## **LONGYUAN MULILO DE AAR MAANHAARBERG WIND ENERGY FACILITY NEAR DE AAR, NORTHERN CAPE PROVINCE: NOTIFICATION OF PROPOSED AMENDMENT TO THE ENVIRONMENTAL MANAGEMENT PROGRAMME AND LAYOUT PLAN**

**(DEA REFERENCE NUMBER: 12/12/20/1651; DENC REF. NC/BA/05/PIX/EMT/DEA2/2014)**

**Table 1: Summary of proposed amendments to the EMPr and Layout Plan**

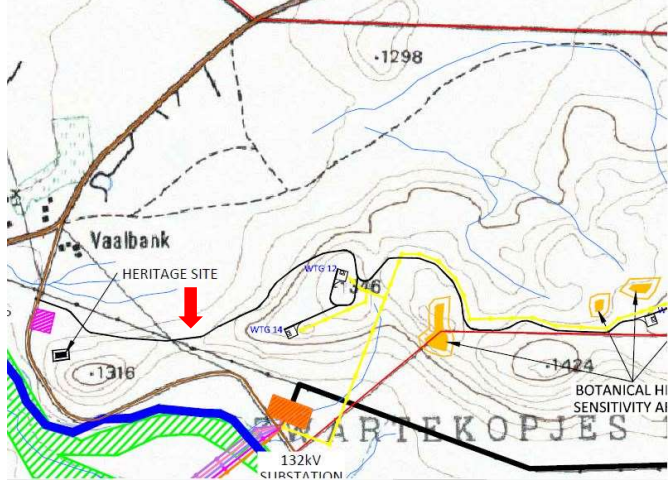
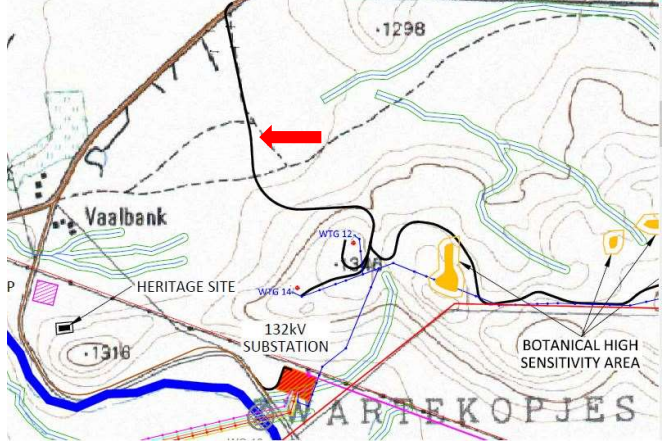
- The approved access road onto the Swartekopjes Mountain has been realigned
- Micro-siting of turbine 21
- Micro-siting of one of the construction camps
- Refinements to the internal 33kV reticulation lines and access roads, some of which have resulted in infringements/ transgressions on buffers (specifically heritage, botanical and freshwater buffers/ sensitivity areas).
